HORSHAM DISTRICT COUNCIL CONSULTATION

TO:	Horsham District Council – Planning Dept
LOCATION:	Chanctonbury Nurseries Rectory Lane Ashington Pulborough
DESCRIPTION:	Approval of details reserved by condition(s) 14, 15 to approved application DC/24/1081.
REFERENCE:	DISC/26/0114
RECOMMENDATION:	More Information / Modification
SUMMARY OF COMMENTS & RECOMMENDATION: The Planting Plans and Planting Schedule are unchanged from those submitted under refused DISC/24/0129. As such, our concerns remain unaddressed and are repeated below for ease, in combination with updated comments in relation to coordination with documentation submitted under DISC/24/0121, DISC/24/0304, DISC/0309 and DISC/25/0136.	
MAIN COMMENTS: <u>Condition 14</u> <i>Within three months of the date of this decision full details of all hard and soft landscaping works shall have been submitted to and been approved, in writing, by the Local Planning Authority. The details shall include plans and measures addressing the following:</i> a) <i>Details of all existing trees and planting to be removed and retained as required under Condition 7</i> 1. Minor changes to the layout result in conflict with the Tree Protection Fencing (TP

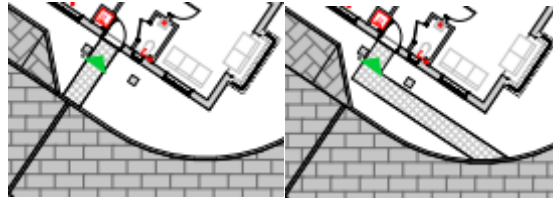
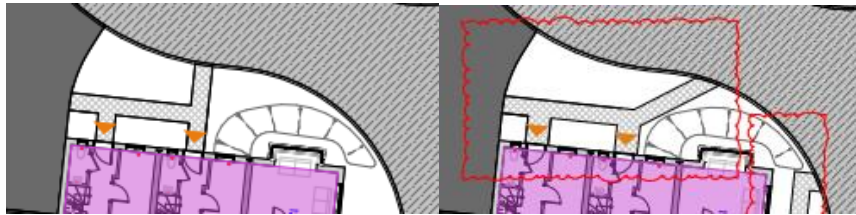
3. As previously commented under refused DISC/24/0129:

- a. Please increase size of *Quercus robur* in the front entrance to Heavy standard 12-14 girth for more instant impact in order to provide a designed sense of arrival.

- b. In order to provide a designed sense of arrival and in order to soften the built form, we recommend 1No. or 2No. trees adjacent to plot 3 and/or a continuation of hedgerow.

- c. We recommend a further 2No. native trees within the southern open space as a minimum, such as *Sorbus torminalis* and *Salix caprea*.
- d. Planting should be introduced to the attenuation basin area (previously described as a balancing pond) to help it blend more aesthetically into its surroundings.

- e. Please include wildflower and hedgerow mixes to the planting schedule.
- f. Please amend tree pit details to state that backfill should replicate existing soil profile by using soil excavated from planting pits, only amended with imported soils if necessary. No fertiliser should be used.

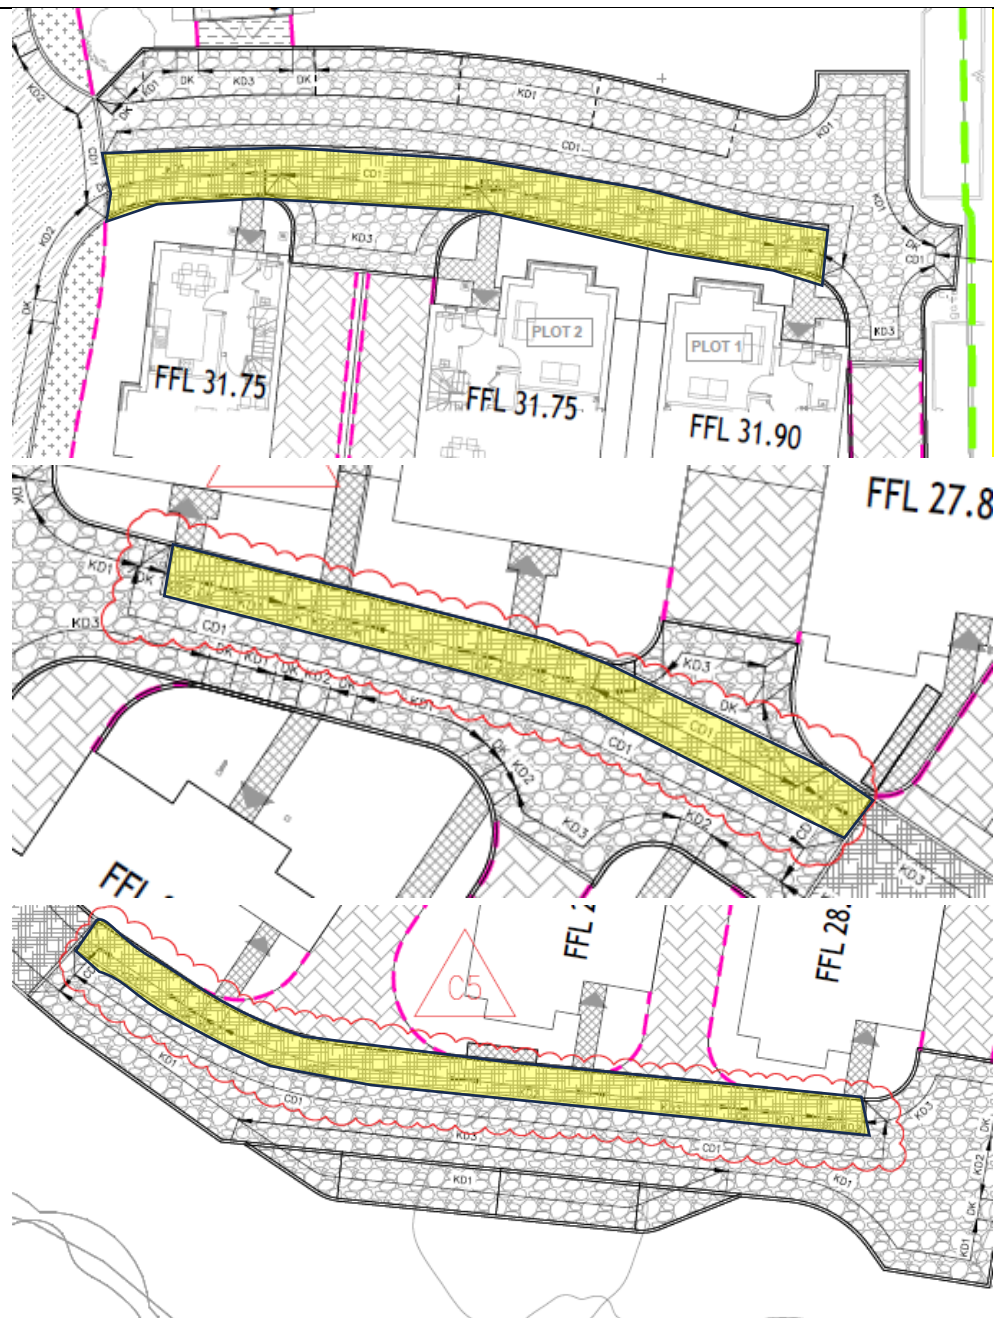
5. As per point 1, proposed changes to the approved external works scheme, while minor in some instances, incrementally are deemed unnecessary and result in an overall increase in hard surfacing, at odds with the location on the countryside edge. As per point 1, we strongly recommend that the external works layout is reverted to that approved under DISC/25/0136. Please see non-exhaustive examples below, with current proposals to the right, noting that the first example results in conflict with a proposed tree.

6. Please specify areas in yellow below as permeable paving to reflect the approved drainage layout under DISC/24/0309.

DISC/24/0304 – Combined services [left], Drainage layout - DISC/24/0309 [middle], current/previously refused Planting plan [right]

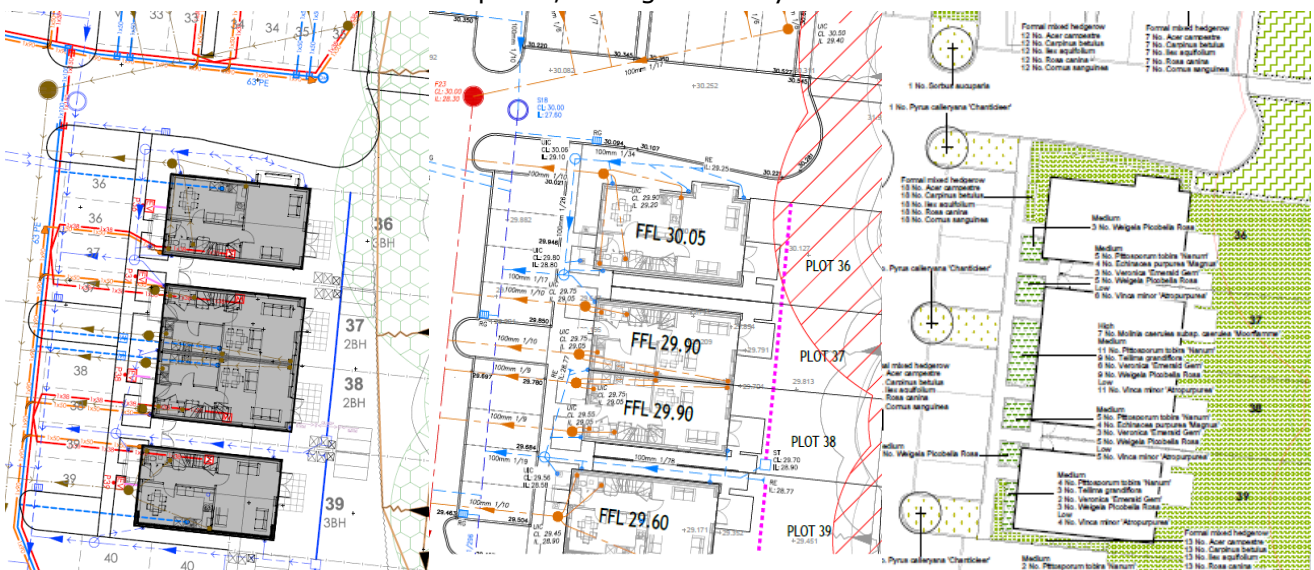
15. Combined services have been approved under DISC/24/0304, notwithstanding areas of discrepancy with the drainage layout approved under DISC/24/0309. In any case, both layouts demonstrate conflict with the landscape strategy and as a result must be amended accordingly. Please see following examples where amendments are required, noting that they are not exhaustive:
